PREPARED FOR:  
MCDONALD'S CORP 016-0064  
LOUISVILLE, KY  
2961 BRECKENRIDGE LANE, LOUISVILLE, KY  
016-0064 LOUISVILLE, KY - C3.0 SITE PLAN

SHEET NO.  
**C3.0**

20-CAT2-0037

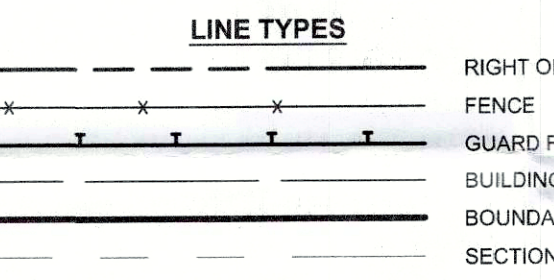
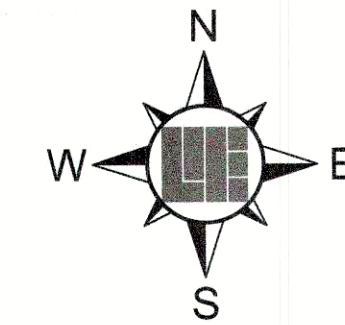
- 1-19-22**
- Transfer all comments.
  - Put all MSD notes in their own section on the plan.
  - Add WM#9251 / 21 1192 (Add the red number to the WM#)
  - Note: Construction plans and documents shall comply with Louisville and Jefferson County Metropolitan Sewer District's Design Manual and Standard Specifications and other local, state and federal ordinances.

- Note: all retail shops must have individual connections per MSD's fats, oil and grease policy.
  - Note: Onsite detention is being provided by the existing underground basin. Post developed drainage curve number shall be equal to or less than existing drainage area. To be evaluated prior to MSD construction plan approval. May be subject to KYTC approval.

- Show all existing and proposed storm structures/lines.
  - Show all existing and proposed sewer lines. Clearly show the existing sewers coming from the Breckenridge lane ROW. Show these sewers up to the first structure onto the subject site in a 15' public sewer easement. Call out the remaining sewers to remain private.

- Show the sewer relocation required route them around the building. The relocated portion shall be installed as an 8" sewer.
  - Note: Sanitary sewer service provided by existing PSC. Private Lateral extension required for any sewer relocation, subject to Fee's and any applicable charges.

- Either add the 1<sup>st</sup> note if the area of disturbance is over an acre or add the 2<sup>nd</sup> note if it less than an acre but insert your area of disturbance in place of the XXXX's. Note 1: The final design of this project must meet all MS4 water quality regulations established by MSD. Site layout may change at the design phase due to proper sizing of Green Best Mgmt. Practices. -OR- Note 2: Note: This project is subject to MS4 Water Quality Regulations once the incremental area of disturbance sums equal to or greater than 1 acre of disturbance. Per this preliminary development plan, the area of disturbance is XXXX S.F. (fill in the XXX) (Disturbance is defined as where the soil is being disturbed. Work in the paved area where the soil below the existing subgrade is not being disturbed will not count.)

- List the total site disturbance, existing impervious, proposed impervious and the net increase/decrease of impervious area on the plan.
  - Note: An EPSC plan shall be developed and approved in accordance with MSD Design Manual and Standard Specifications prior to construction plan approval.
